Mayberry, Colorado Springs

Filing No. 3

Construction Drawings

MAYBERRY, COLORADO SPRINGS - FILING NO. 3

EL RENO LANE PLAN & PROFILE

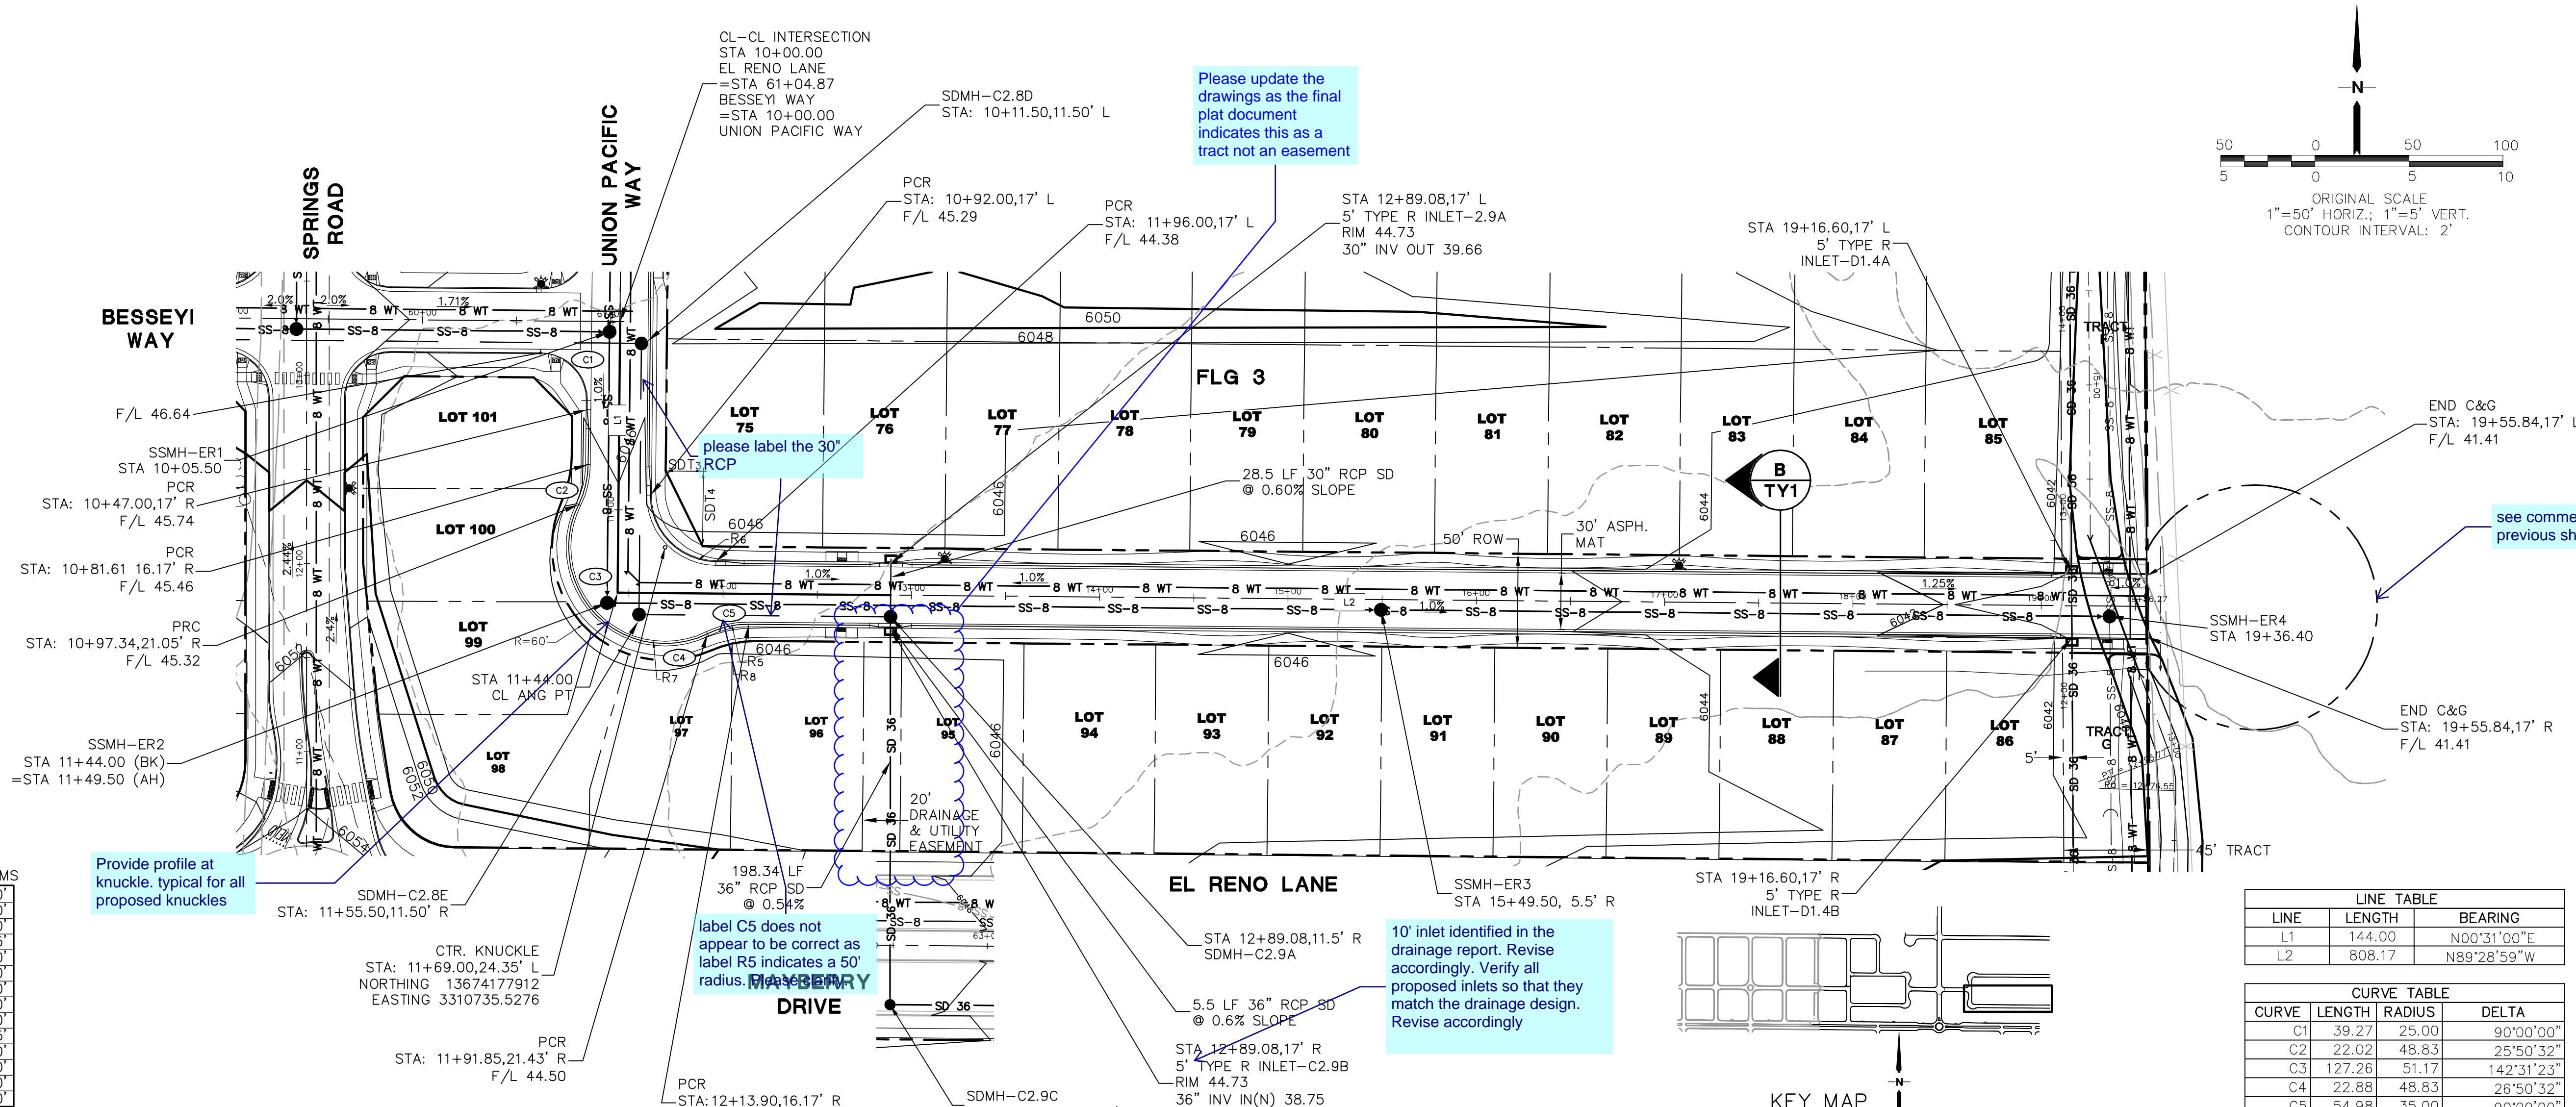
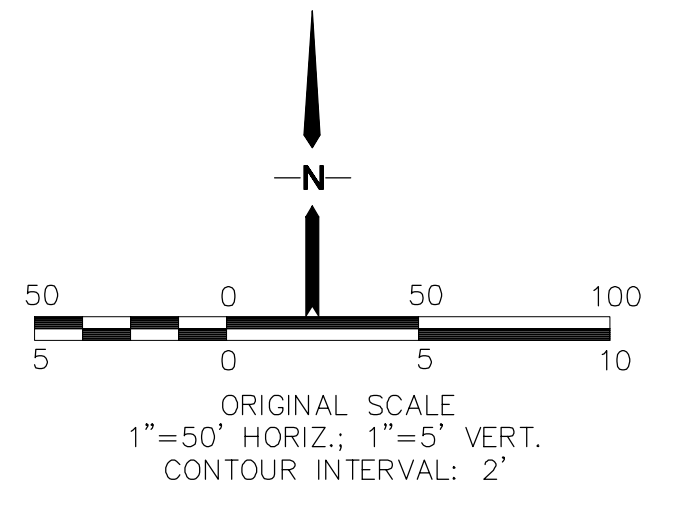
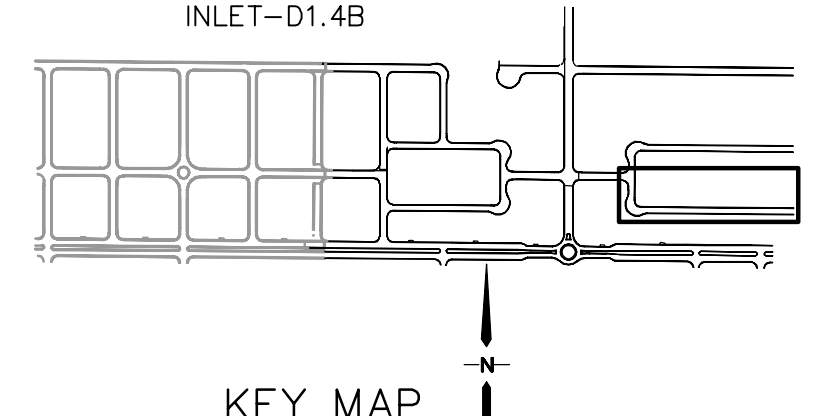
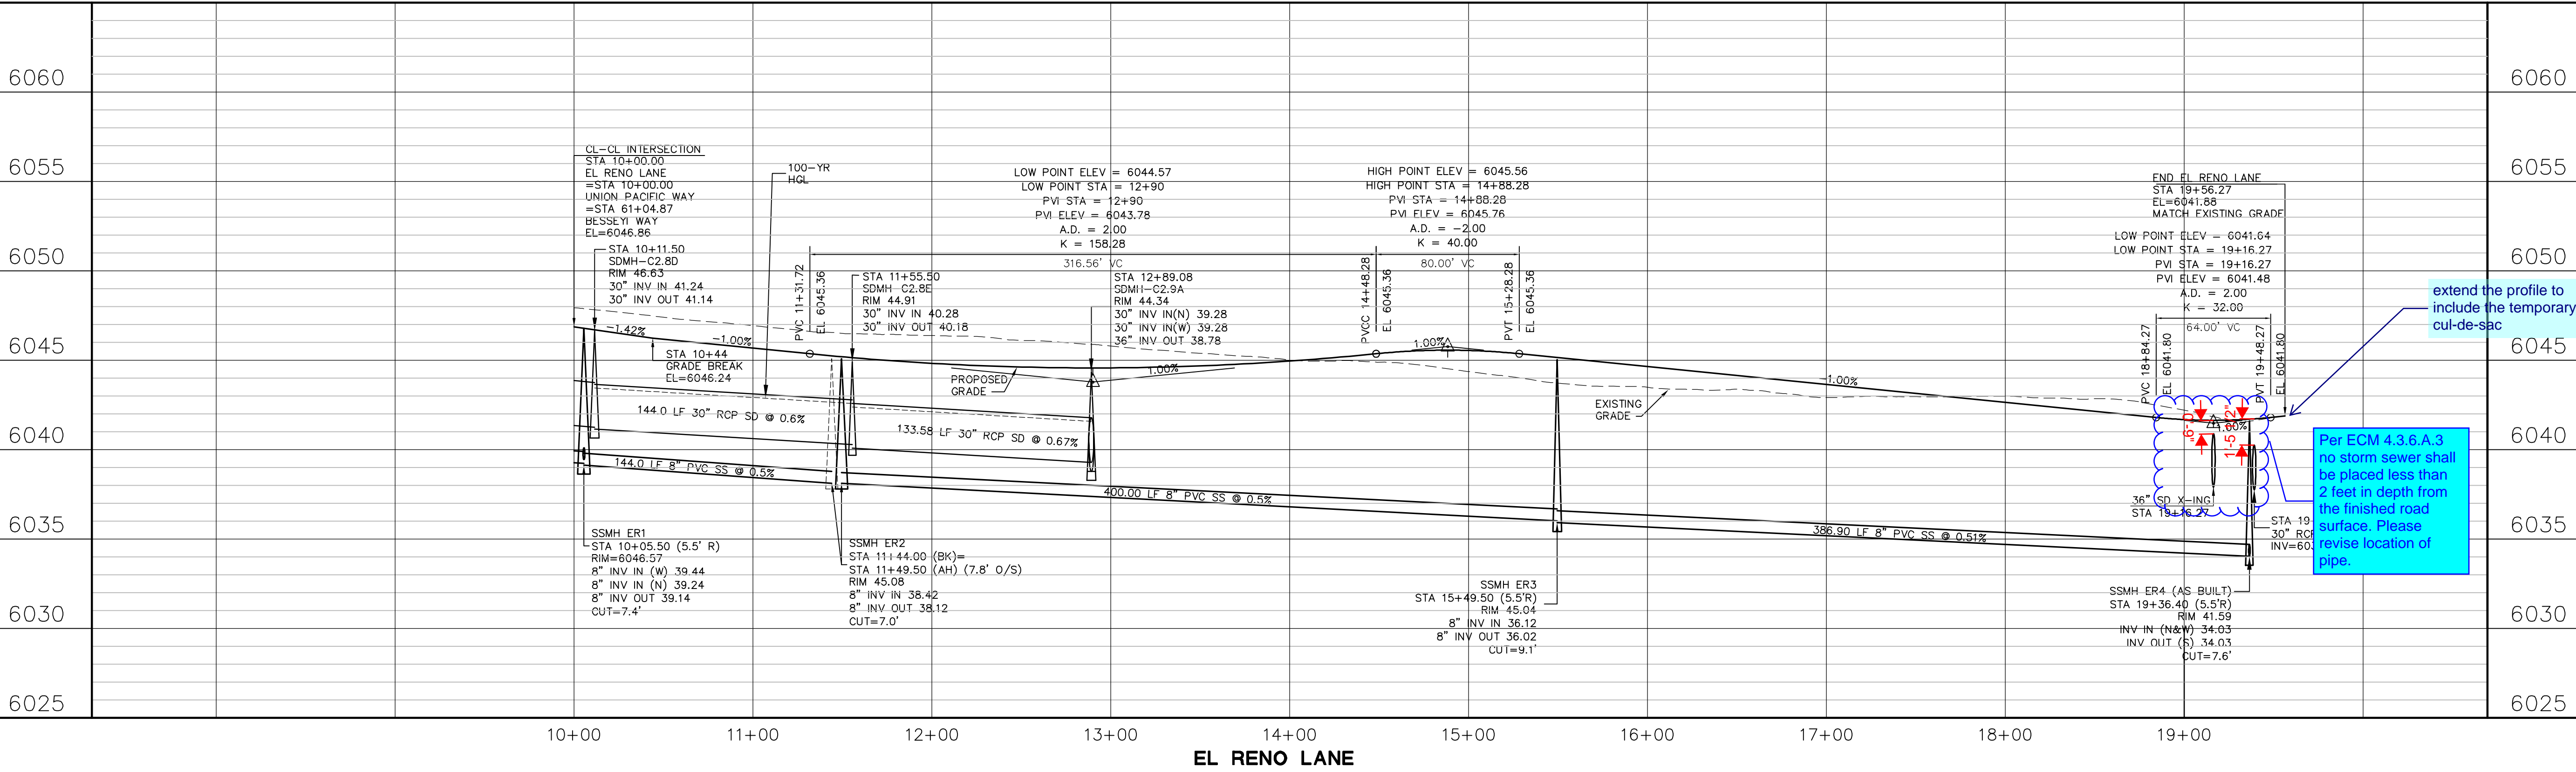
provide profile at knuckles, typical for all proposed knuckles

label C5 does not appear to be correct as label R5 indicates a 50' radius.

Please update the drawings as the final plat document indicates this as a tract not an easement

10' inlet identified in the drainage report. Revise accordingly. Verify all proposed inlets so that they match the drainage design. Revise accordingly

see comment on previous sheet

Per ECM 4.3.6.A.3 no storm sewer shall be placed less than 2 feet in depth from the finished road surface. Please revise location of pipe.

EAST STORM DRAIN PLAN & PROFILE

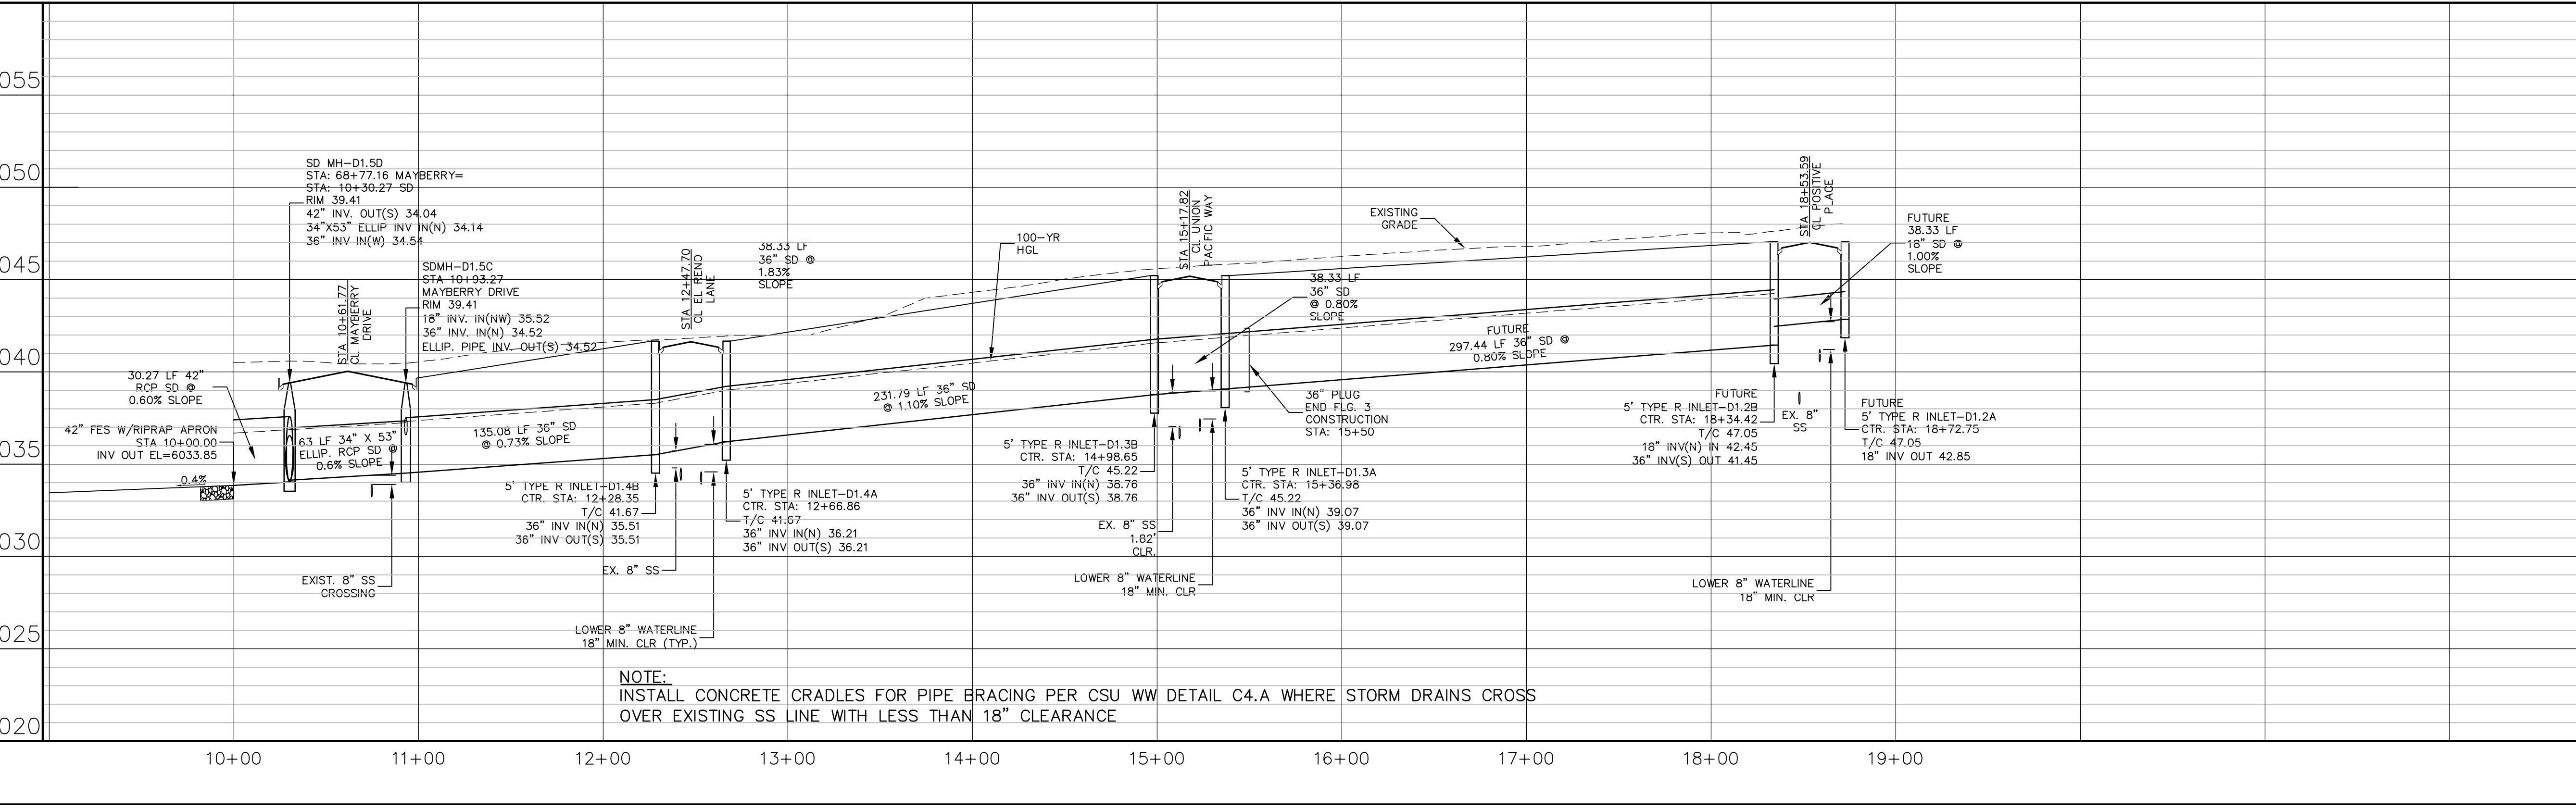
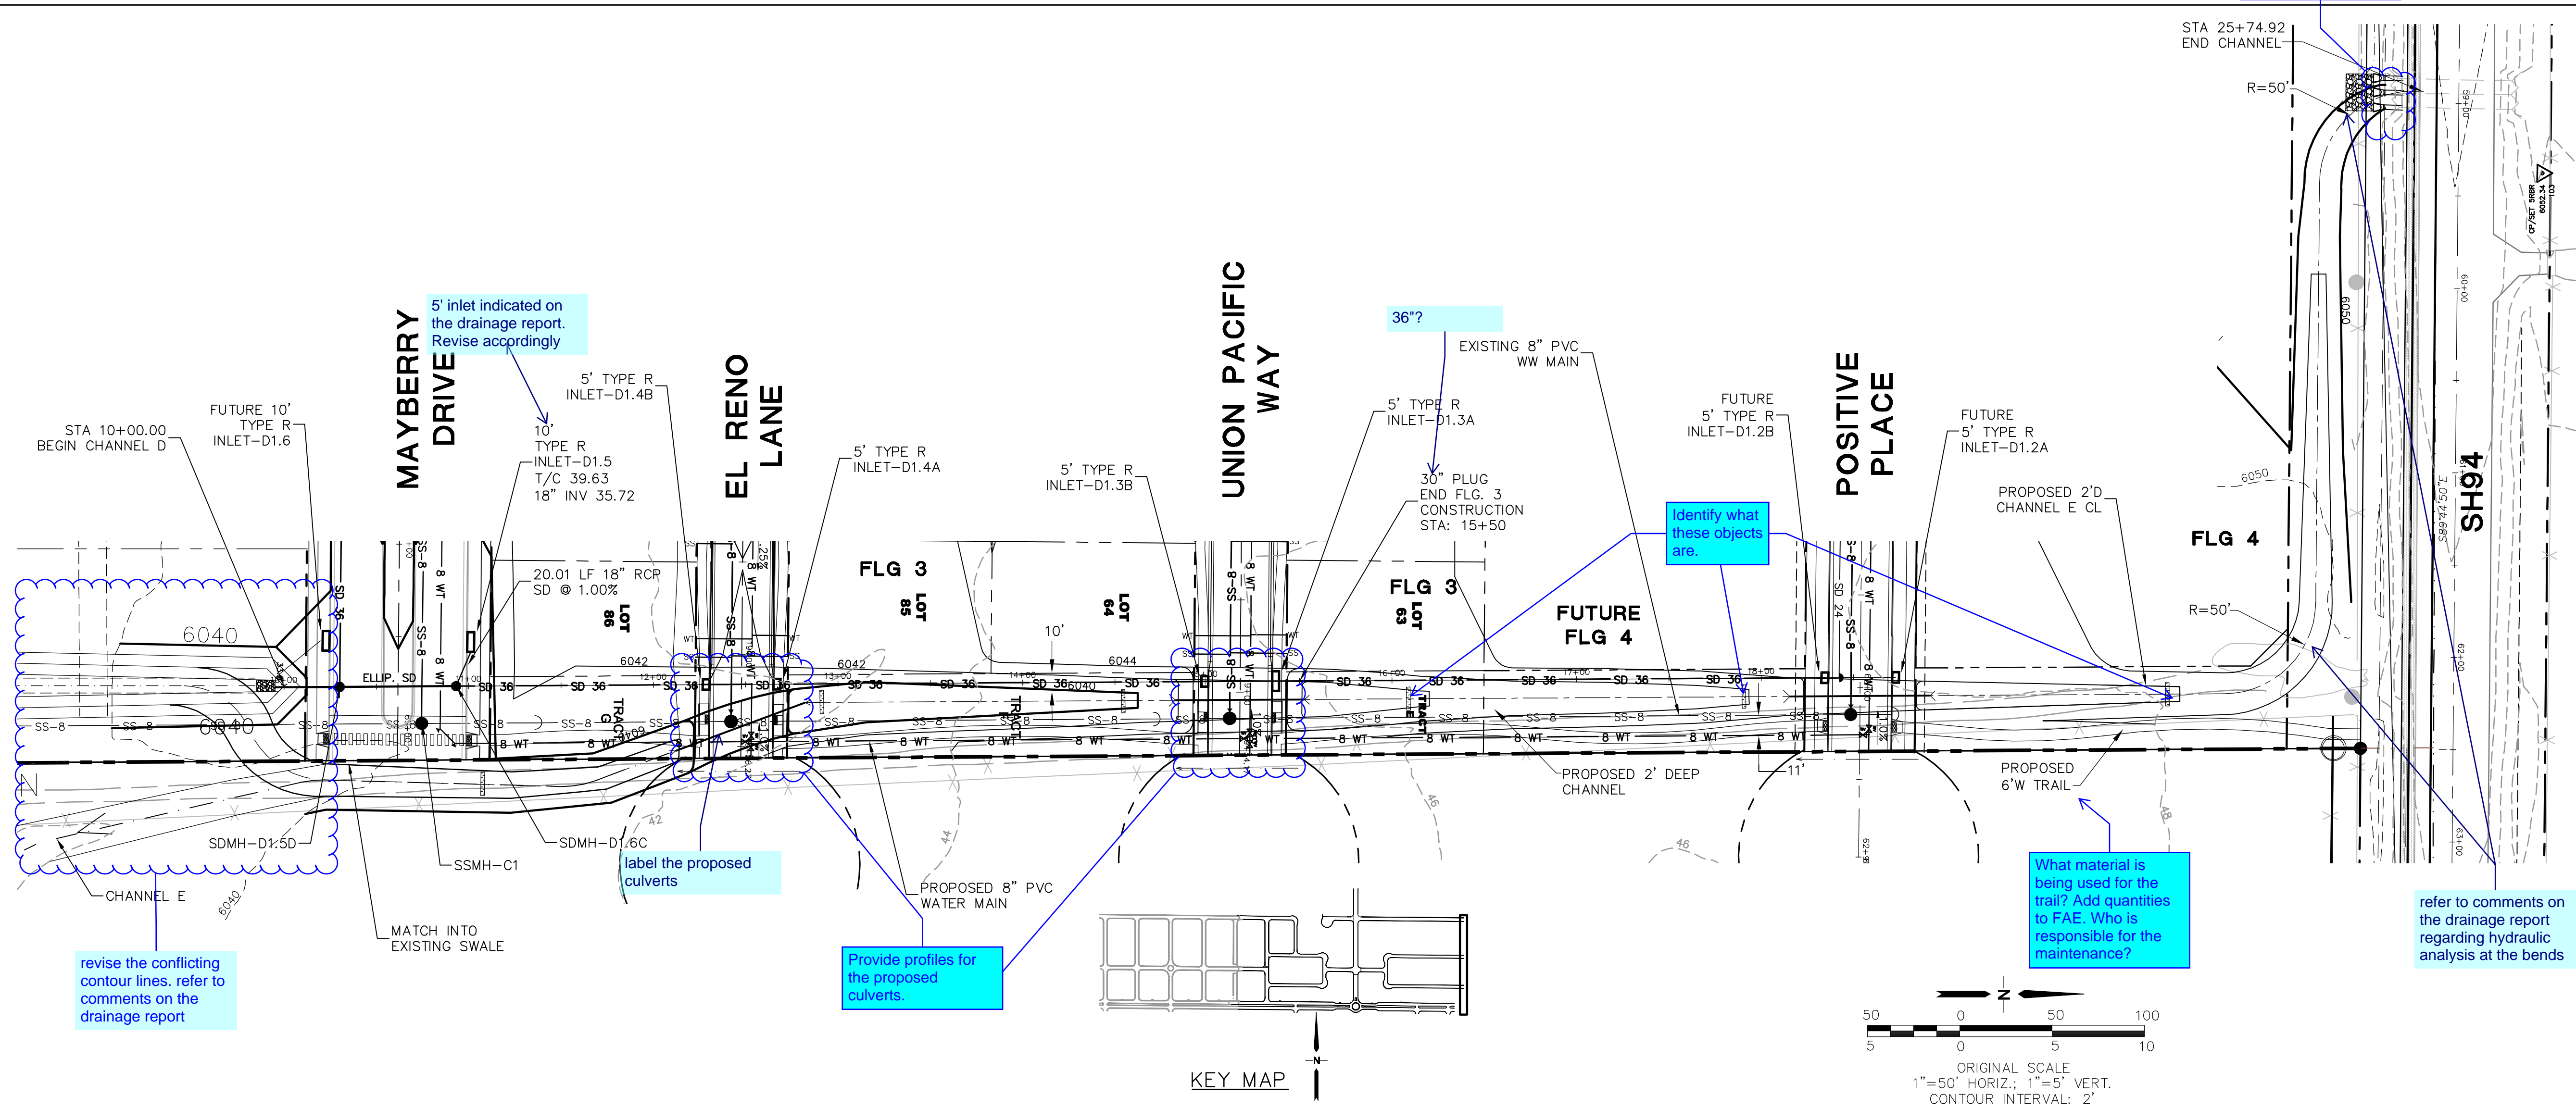
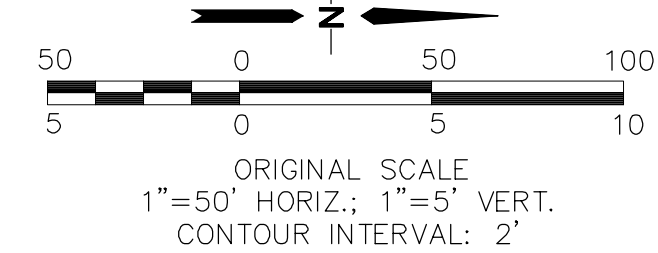
Show contour tie-ins.

revise the conflicting contour lines. refer to comments on the drainage report

5' inlet indicated on the drainage report. Revise accordingly

label the proposed culverts

Provide profiles for the proposed culverts.

36"?

What material is being used for the trail? Add quantities to FAE. Who is responsible for the maintenance?
